Transmitter Waveform Template

Howard Baumer

04-Mar-2006

Changes to Definitions

Transmit Time Domain Template

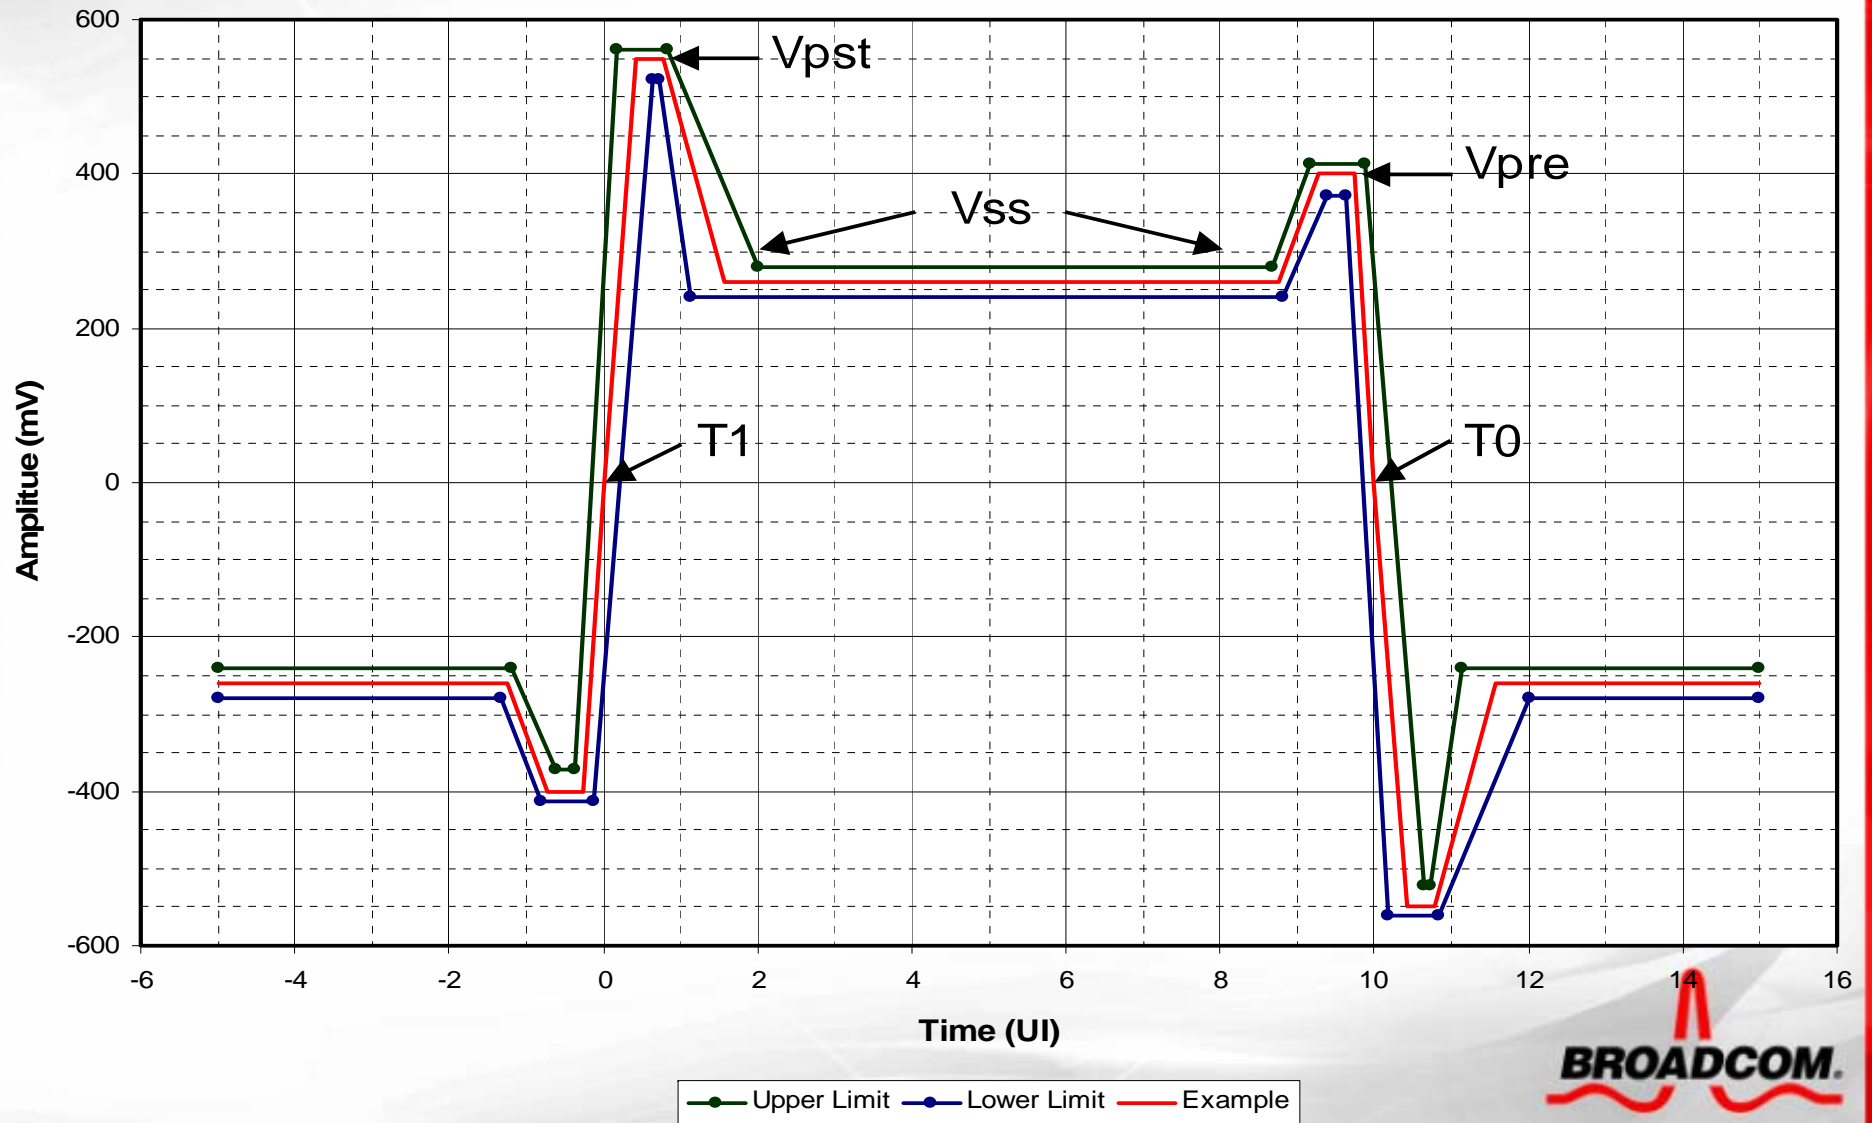
- Table 72-2, P120: Sign change on the V_{pre} coefficient update
- 72.7.1.11, P121, L41: Definition of V_{pk} was deleted yet it is referenced in item "d" & "e". Add the definition back in: $V_{pk} = V_{pst} + V_{pre} - V_{ss}$
- Figure 72-14, P122: t_0 & t_1 swap places
- 72.7.1.11, P122, L28: t_0 = zero-crossing point of the falling edge of the AC-coupled signal
- 72.7.1.11, P122, L29: t_1 = zero-crossing point of the rising edge of the AC-coupled signal
- 72.7.1.11, P122, L30: V_{pre} = maximum voltage measured in the interval $t_0 - T$ to t_0
- 72.7.1.11, P122, L31: V_{pst} = maximum voltage measured in the interval t_1 to $t_1 + T$
- 72.7.1.11, P122, L32: V_{ss} = steady-state voltage measured as the average voltage in the interval $t_1 + 2T$ to $t_0 - 2T$
- 72.7.1.11, P122, L38: $R_{pre} = V_{pre}/V_{ss}$
